Planning and Development Services Division Vote Report

Meeting Date: January 23, 2017

Petition: **P.Z. 05-2016 Wildhorse Baxter Center, C148B (Shelbourne Senior Living):**
A request for a zoning map amendment from a “C-8” Planned Commercial District to a “UC” Urban Core District for 5.21 acres located south of Wild Horse Creek Road and east of its intersection with Baxter Road (18T630283).

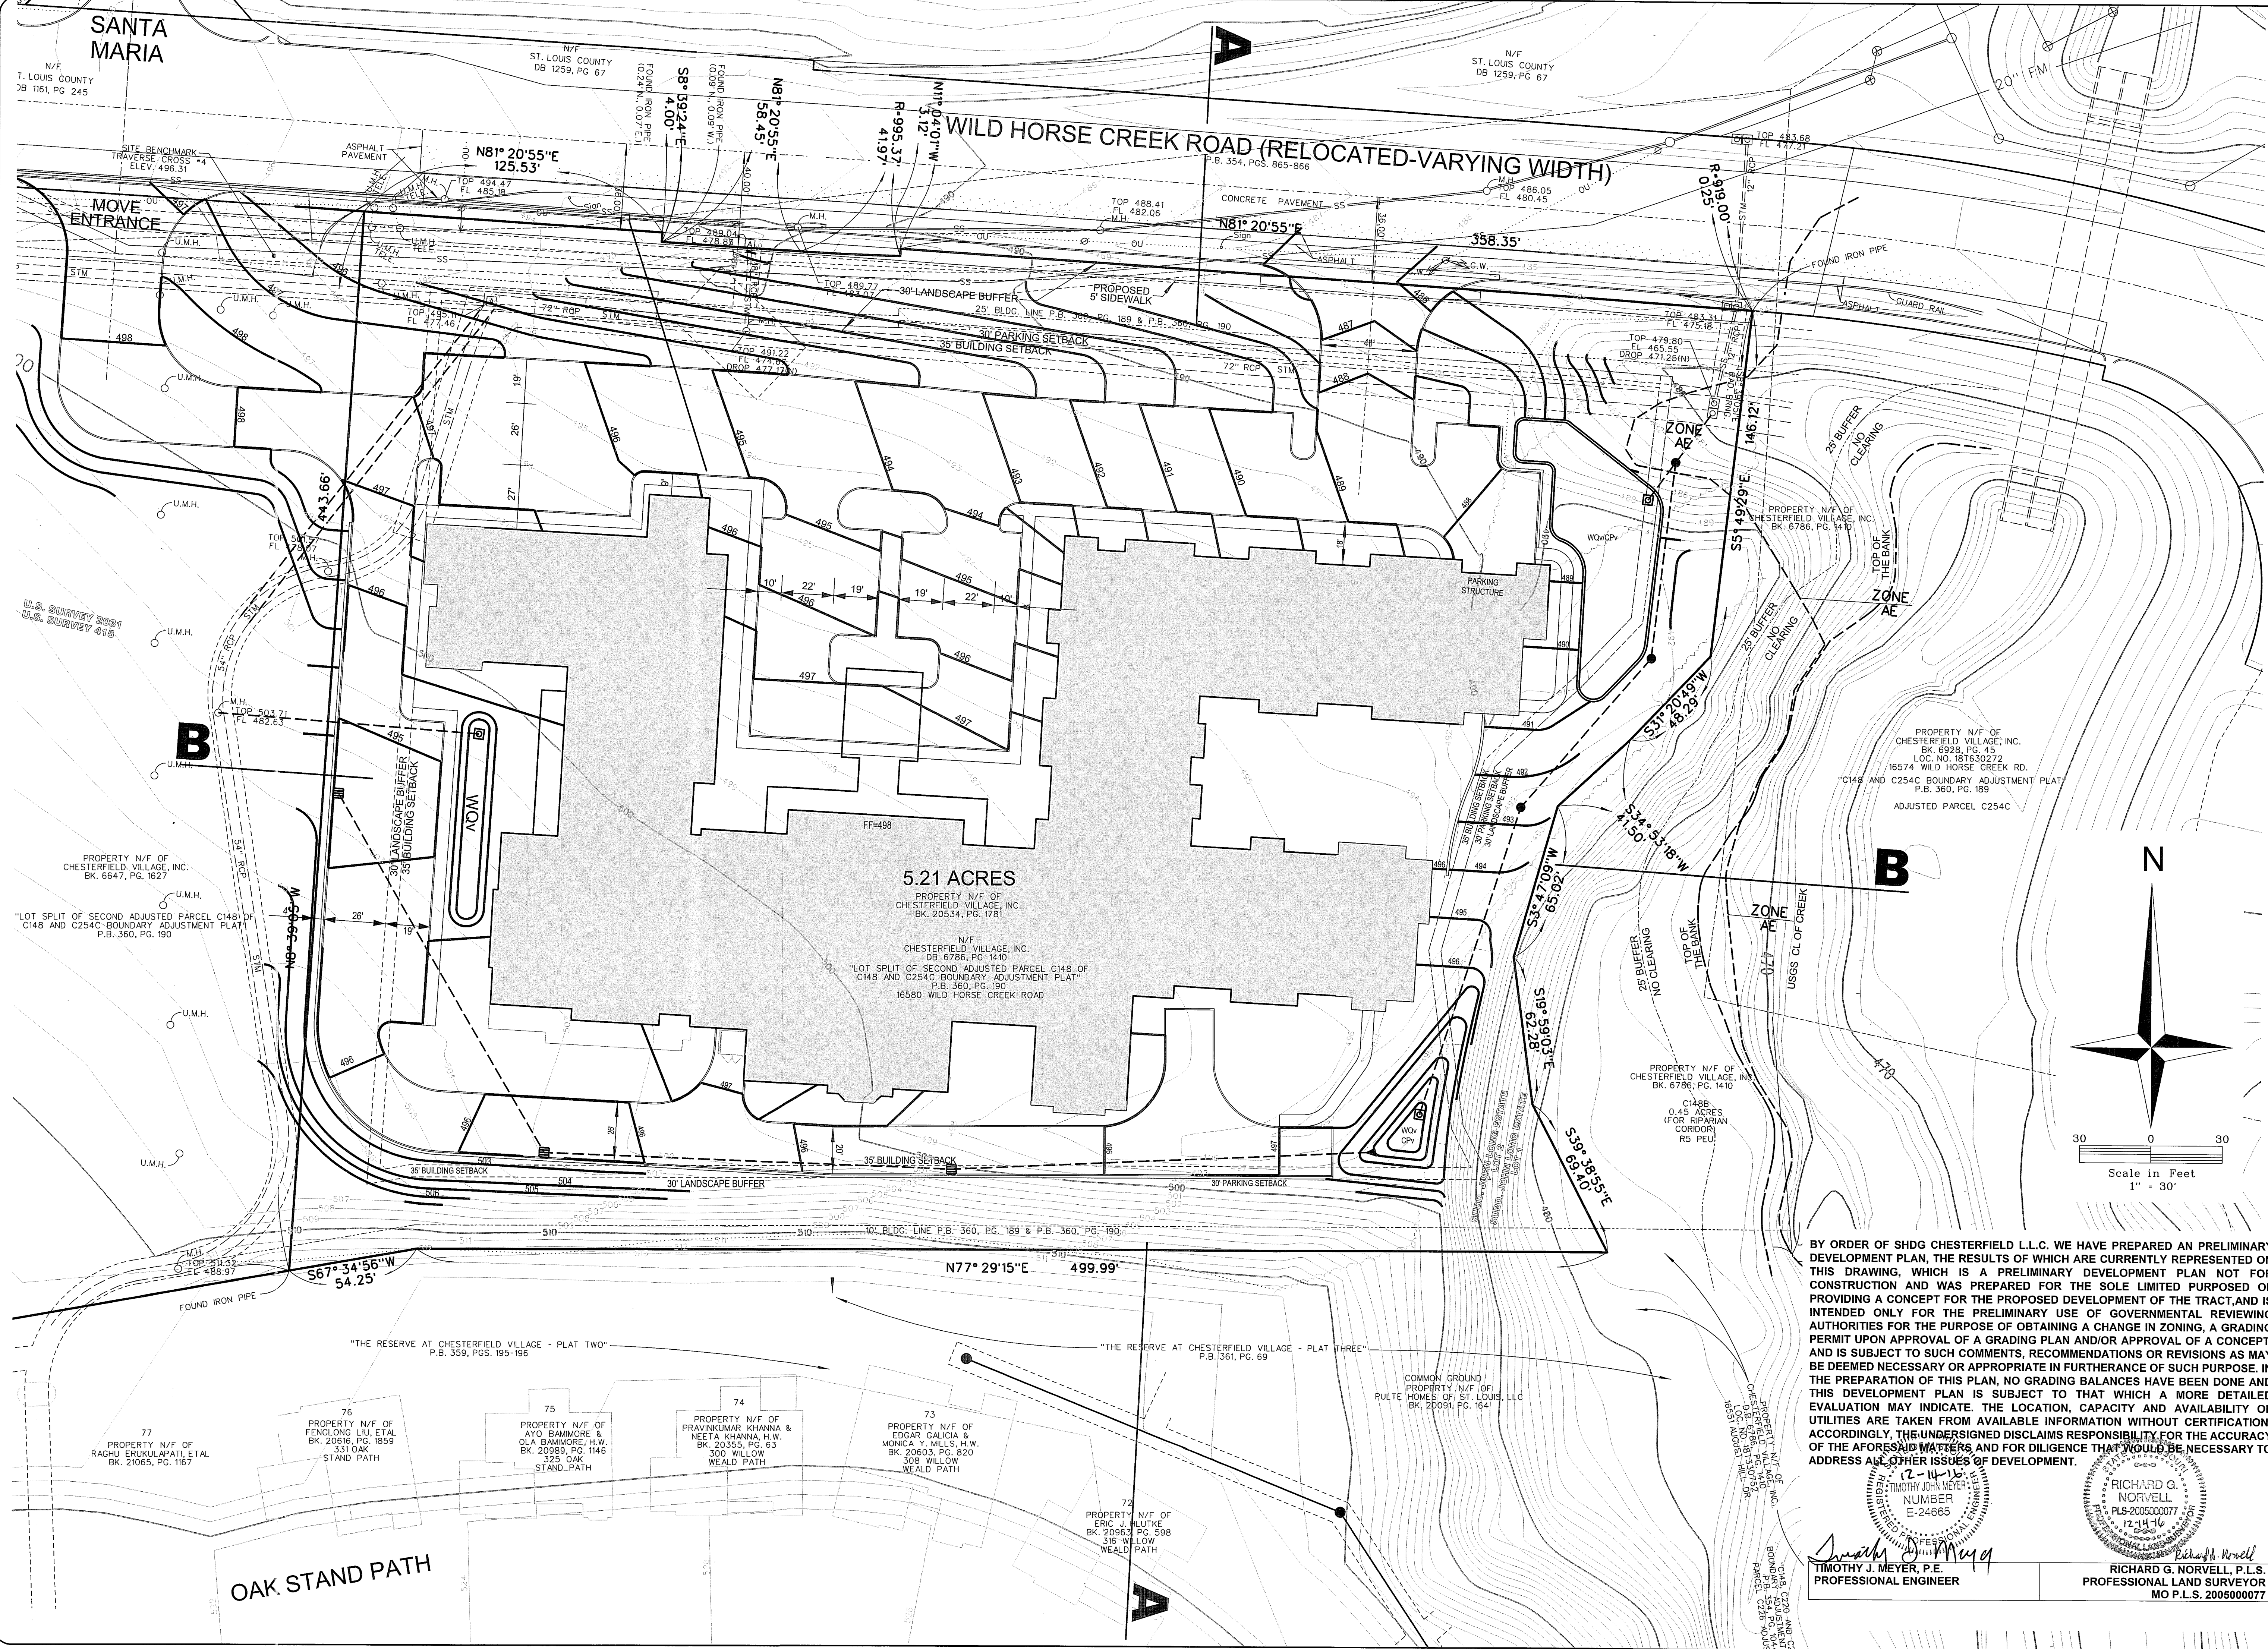
3. Concerns were expressed regarding the proposed height of the facility – specifically the four story portions of the building. Clarify the Preliminary Plan to clearly reflect the location of 3-story sections versus 4-story sections of the building and consider revising the proposal to eliminate any 4-story portions of the building.

5. Address noise from the development and the impact of the noise on adjoining properties. Noise sources to be considered include, but are not limited to, emergency response vehicles, building mechanical equipment, parking areas, ect.

6. The proposed off-site access location does not comply with access management standards. A restriction preventing use of this driveway location until such time as the access is brought into compliance with City and County access management standards will be included in the Attachment 'A' for the development.

After much study and review of alternative designs and plans, Petitioner has developed a concept design and plan that reduces the height to three stories. To accomplish that result Petitioner requests that the Planning Commission modify the West setback as shown on the revised Preliminary Plan submitted contemporaneously with this letter. Reducing the setback on the West has no adverse effect. The adjacent commercially zoned parcel on the West (C-148A) is owned by the same entity that owns the subject site (C-148B), and it has no objection to a reduction of the setback on the West.

Because of the topography, expanding the buffer has no benefit. In addition, the reduction in height does provide a significant benefit to the adjoining residences and could not be accomplished if the buffer is expanded beyond what is shown on the revised Preliminary Plan.

Petitioner responded to this issue in a previous letter dated August 4, 2016 and incorporates that response by reference. Petitioner intends to comply with all applicable City regulations.

Petitioner agrees to relocate the off-site access location as requested by staff, and the owner of the off-site Parcel (C-148A) has consented to that relocation.
